MADISON MARKET
SAN ANTONIO, TEXAS
BEXAR COUNTY

MASTER DEVELOPMENT PLAN
No. 030-07

November 21, 2007

Re: **Madison Market** **MDP # 030-07**

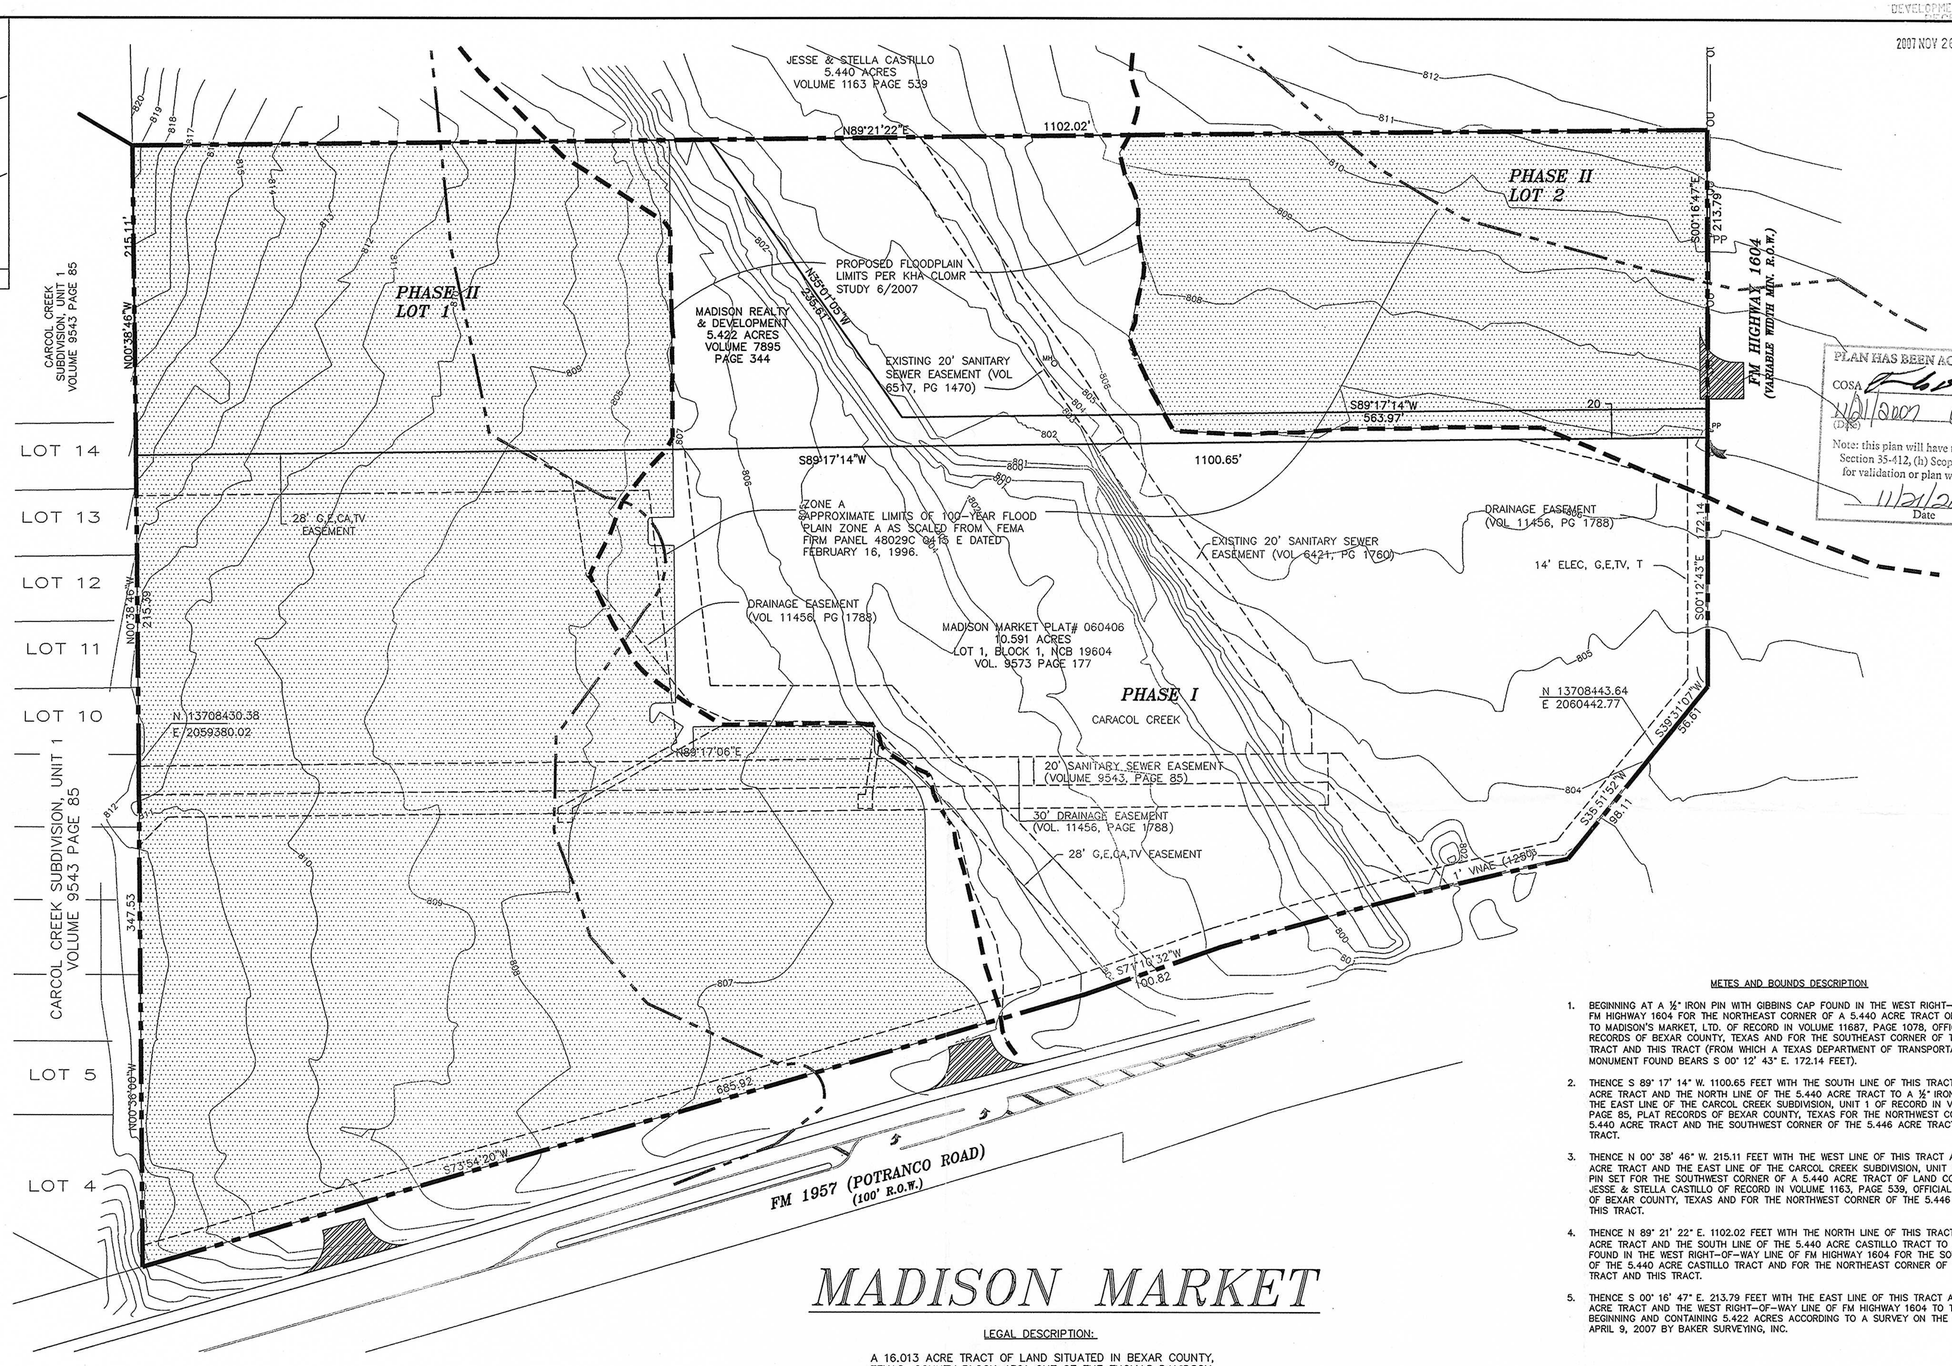
In consideration of public safety and convenience, excessive grades by reason of topography should be avoided in street layouts and arrangements. Any access and R.O.W. issues along state facilities will need to be resolved with the **Texas Department of Transportation (TXDOT).** For information about these requirements you can contact TXDOT at 615-5814.

- All access roadways shall provide clear sight distance on all existing and proposed roadways in order to provide adequate obstruction free viewing distances for approaching traffic. All signage, landscaping, and improvements shall be selected and located so as to not block these clear sight distance areas.

- All commercial driveways for this project shall comply with UDC 35-506(r) Access and Driveways.

- All driveway access points along Loop 1604 shall be coordinated through TXDOT.

- Coordinate all proposed modifications to traffic signal timing settings on Potranco Road & Waterstone Place with City of San Antonio Public Works Department.

- Coordinate all proposed modifications to traffic signal timing settings on Potranco & NB & SB Loop 1604 with City of San Antonio Public Works and with TXDOT.

- 2006 Tree Preservation ordinance standards per UDC Section 35-523 – A Tree Preservation Plan with 40% preservation of protected trees and 100% of heritage trees is required prior to any work on site. This can be submitted either as a site work permit, at the platting or building permit stage.

- Landscape ordinance per UDC Section 35-511. It appears some lanscape points can be met by preserving existing vegetation as well as meeting any mitigation requirements (eighter through preservation of smaller material or transplanting). Recommend securing knowledgeable Landscape Architect at planning and design phase to better utilize existing trees and vegetation. Preservation will eliminate the need for irrigation. Staff would be willing to meet with developer at design stage to assist with tree preservation and landscape plan.
